**Town of Kittery Maine
 Planning Board Meeting
 December 13, 2018**

ITEM 5 - 50 Chauncey Creek Drive – Shoreland Development Plan Review.

Action: Accept or deny application. Approve or deny plan. Owners and applicants, Thomas and Michele Jordan request consideration to reconstruct and expand a nonconforming single family dwelling on a 7,800 +/- square foot parcel located at 50 Chauncey Creek Road (Tax Map 44 Lot 59) in the Residential Kittery Point Village (R-KPV), Shoreland Overlay (OZ-SL-250’) and Resource Protection (OZ-RP) zones. Agent Tom Emerson, studioB-E.

SHORELAND DEVELOPMENT PLAN
 FOR PROPERTY AT
50 Chauncey Creek Road
 Kittery Point, York County, Maine
 OWNED BY
Thomas D. Jordan
Michele Jordan
 24 Barnum Place, Ridgefield, CT 03877

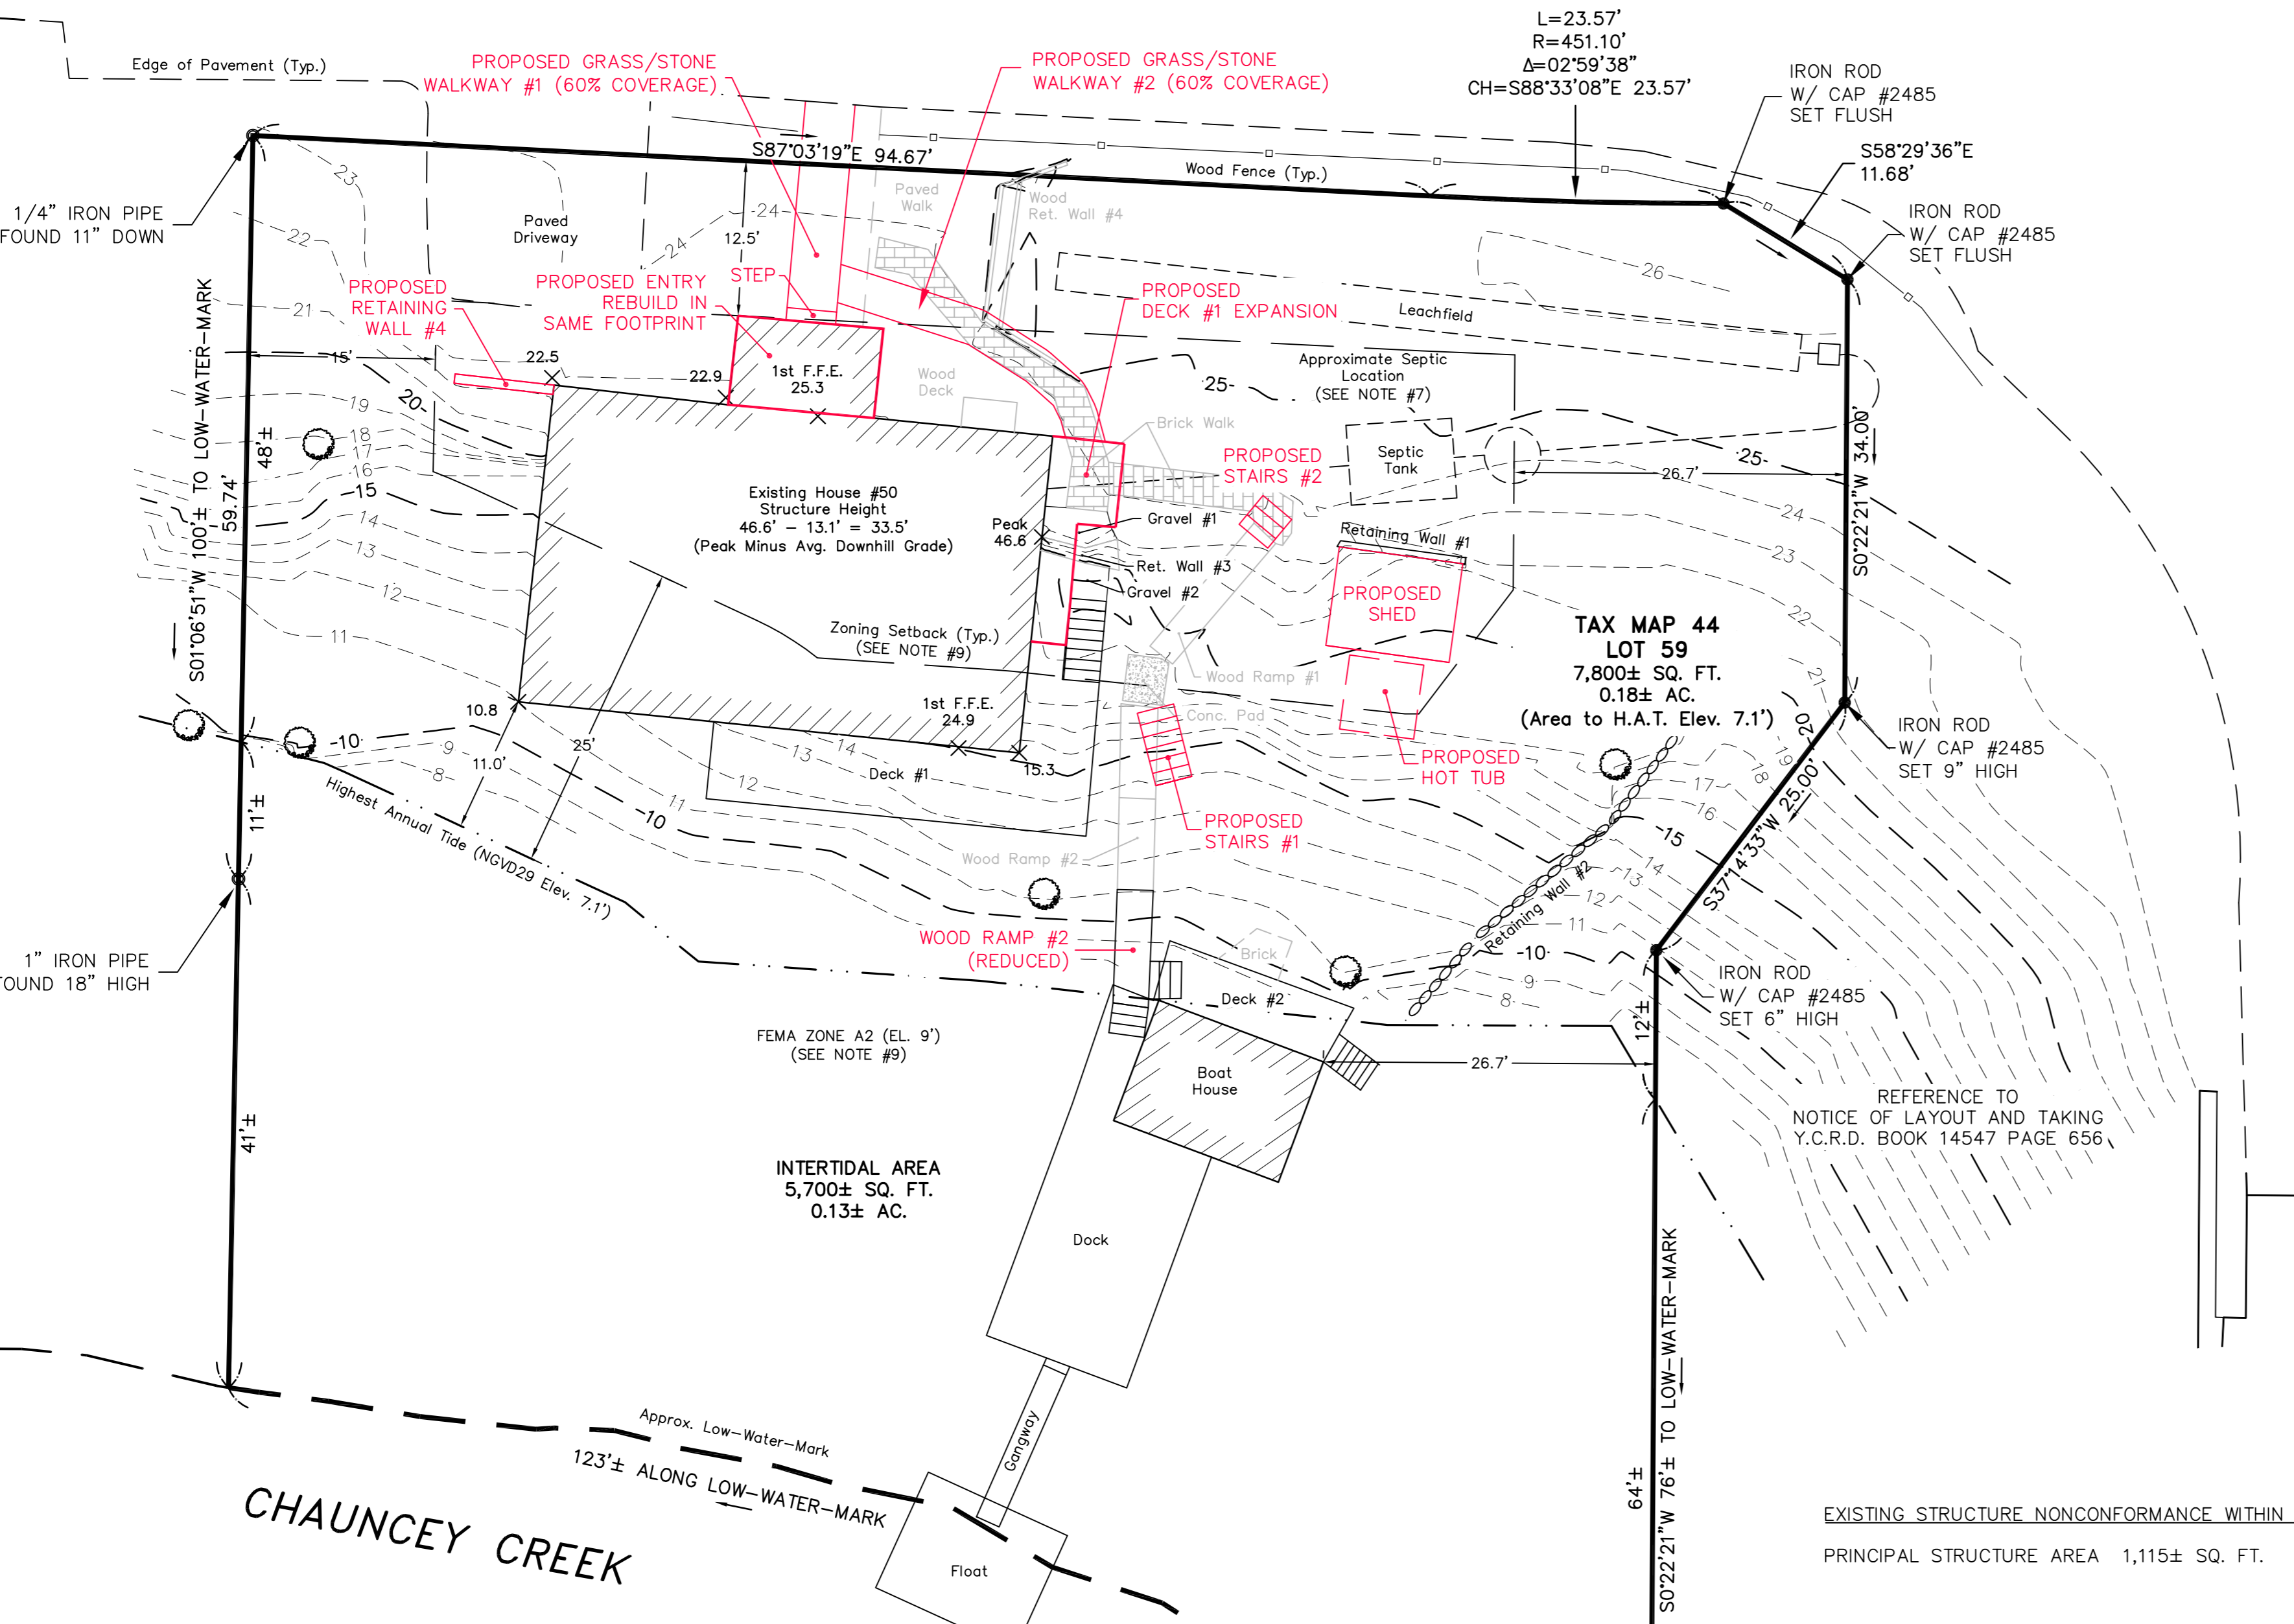
[truncated] Because the deck is considered a structure and is attached to the principal structure, the proposed expansion of deck #1 would need to meet this section of the code. The footprint of the existing dwelling is 1,115 sf and 30% would increase this by 334.5 sf. The proposed deck expansion is 67 sf, so it appears to conform with this section of the code, however, this needs to be shown on the plans as an expansion of the principal structure.

**exceptions 1-3 do not apply. The proposed hot tub does not conform to this code section as it is considered an accessory structure and the plans depict the hot tub to be within 100 feet, and a portion within 25 feet of the normal high water line.*

- d. Per 16.3.2.17.D (2) (e) *On a nonconforming lot of record on which only a residential structure exists, and it is not possible to place an accessory structure meeting the required water body, tributary stream or wetland setbacks, the Code Enforcement Officer may issue a permit to place a single accessory structure, with no utilities, for the storage of yard tools and similar equipment. Such accessory structure must not exceed 80 square feet in area nor eight feet in height and must be located as far from the shoreline or tributary stream as practical and meet all other applicable standards, including lot coverage and vegetation clearing limitations. In no case will the structure be allowed to be situated closer to the shoreline or tributary stream than the existing principal structure. The proposed storage shed would not be permitted as there is already an accessory structure on the lot, the boathouse.*

- e. Per 16.3.2.17.D (Shoreland Overlay Zone, Standards) the total footprint of the devegetated area cannot exceed 20%. The property is currently non-conforming with about 26.5% devegetated. The proposal calls for removal of a paved path, brick path, wood ramp and a concrete pad along with a reduction in size of two gravel areas. The paved path and a portion of the brick path will be removed and replaced by stones set into grass. It appears that all devegetated areas have been noted on the plans. See the Existing and Proposed Devegetated Coverage Calculations on the plan for details.

- c. Applicant demonstrates that no reasonable access alternative exists on the property.The proposed Stairs #1 and #2 are depicted at 3 feet in width and appear to conform with this code, replacing existing walkways and stairs and reducing the overall devegetated area.

3. It is not clear why the proposed stairs are positioned at an angle – they don't seem to align with wood ramp #2 which exists and is going to remain. How will the residents access the boat house and dock? The plan should provide clarity.

4. Are any improvements proposed for access to the storage shed and hot tub?
5. The path to the entry that is being rebuilt seems to extend beyond the property line into the public ROW. The part that extends into the ROW should be removed from the plans.
